# SERVICE LETTER

No. 770

Piper Aircraft Corporation

Subject: Aileron Sprocket/Chain Inspection.

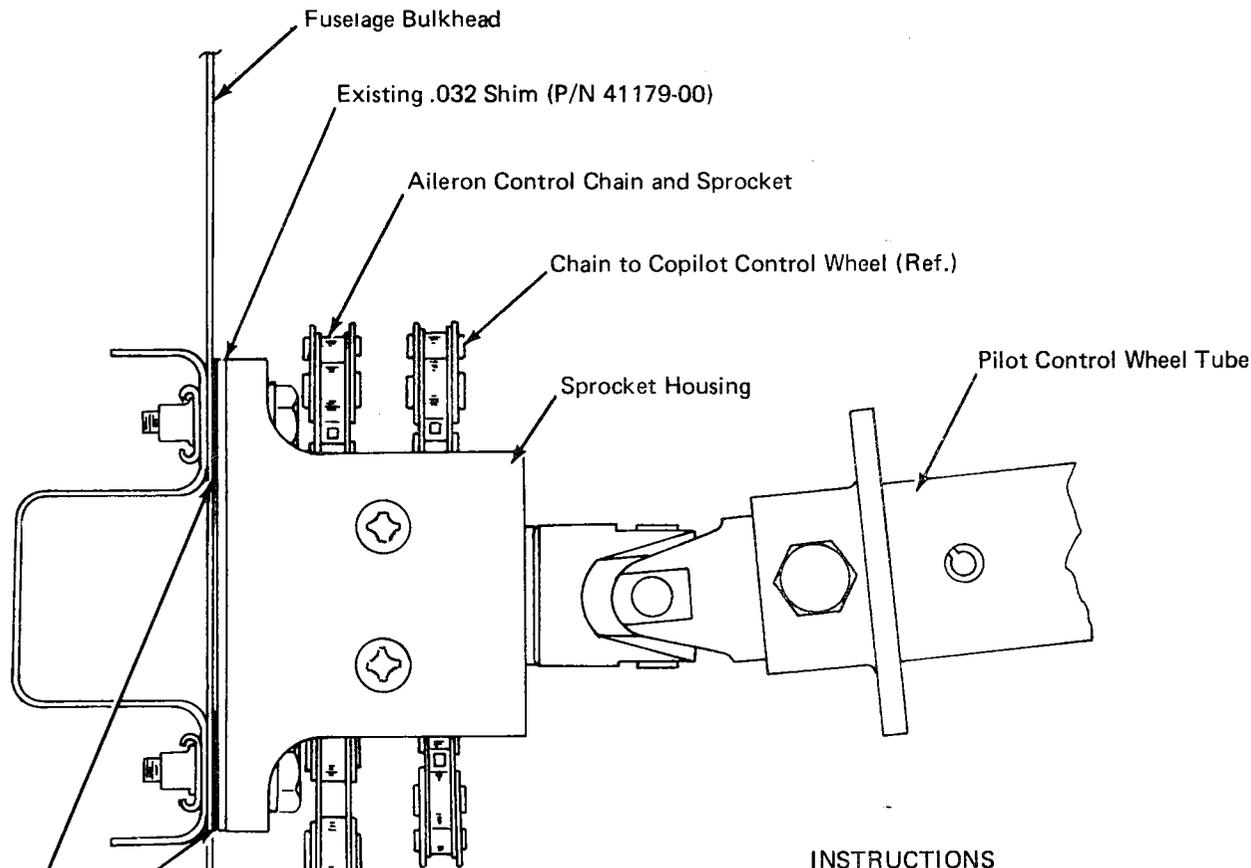
Add new .012 shim (P/N 55817-02) as req. to attain proper vertical alignment of sprocket and aileron control chain.

- a. Inspect at outboard end of sprocket housing to determine if the .032 shim (P/N 41179-00) is installed between the offset in the housing and the bulkhead. Install shim (P/N 41179-00) if it is not present. This shim will ensure proper horizontal alignment.

- b. To attain proper vertical alignment, install new .012 shims (P/N 55817-02) between the top or bottom of the sprocket housing and the bulkhead, as required, to ensure a smooth flow of the chain links over the sprocket.
